# Access Compliance Report

## Public Rights-of-Way

### (Curb Ramps)

Intersection ID: 10789	Main Street: MAHOPAC_ST	Cross Street: S_BRUNS_AV	Location: S
ADA ID: 7E6D5E85442B	Ramp Type: Perp	Initial Pass/Fail: Fail	Overall Compliance: No
		Severity Score: 37.5

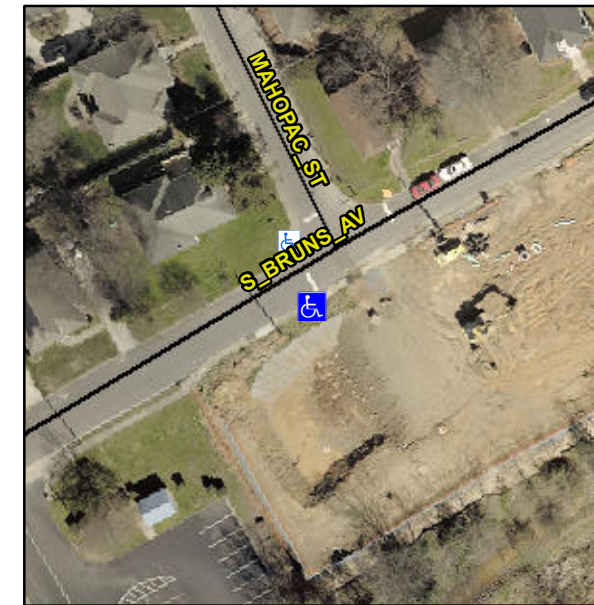
**Not Found, R304.2.2, R304.5.3**

Compliance	Description	Data	Compliance	Description	Data
N/A	Ramp Length (in)	37.0	No	Ramp Slope (%)	11.8
Yes	Ramp Width (in)	48.0	No	Ramp XSlope (%)	7.7
N/A	Flare Type LT	N/A	N/A	Flare Type RT	N/A
N/A	Flare Slope LT (%)	N/A	N/A	Flare Slope RT (%)	N/A
N/A	Flare Traversable LT?	N/A	N/A	Flare Traversable RT?	N/A
N/A	Landing Length (in)	N/A	N/A	DWS Provided?	N/A
N/A	Landing Width (in)	N/A	N/A	DWS Contrast?	N/A
N/A	Landing Slope (%)	N/A	N/A	DWS Length (in)	N/A
N/A	Landing X Slope (%)	N/A	N/A	DWS Full Width?	N/A
N/A	Landing Curb? (Y/N)	N/A	N/A	DWS Offset (in)	N/A
N/A	Shared Landing?	N/A			
N/A	Gutter Ponding?	N/A	N/A	Gutter Slope (%)	N/A
N/A	Gutter Lip Ht (in)	N/A	N/A	Gutter X Slope (%)	N/A
N/A	Painted X Walk1?	No	N/A	Painted X Walk2?	N/A
	X Walk 1 Direction	To N		X Walk 2 Direction	N/A
N/A	X Walk 1 Width (in)	N/A	N/A	X Walk 2 Width (in)	N/A
	X Walk 1 Slope (%)	5.4		X Walk 2 Slope (%)	N/A
	X Walk 1 X Slope (%)	5.6		X Walk 2 X Slope (%)	N/A

**Remove & Replace Entire Ramp.**
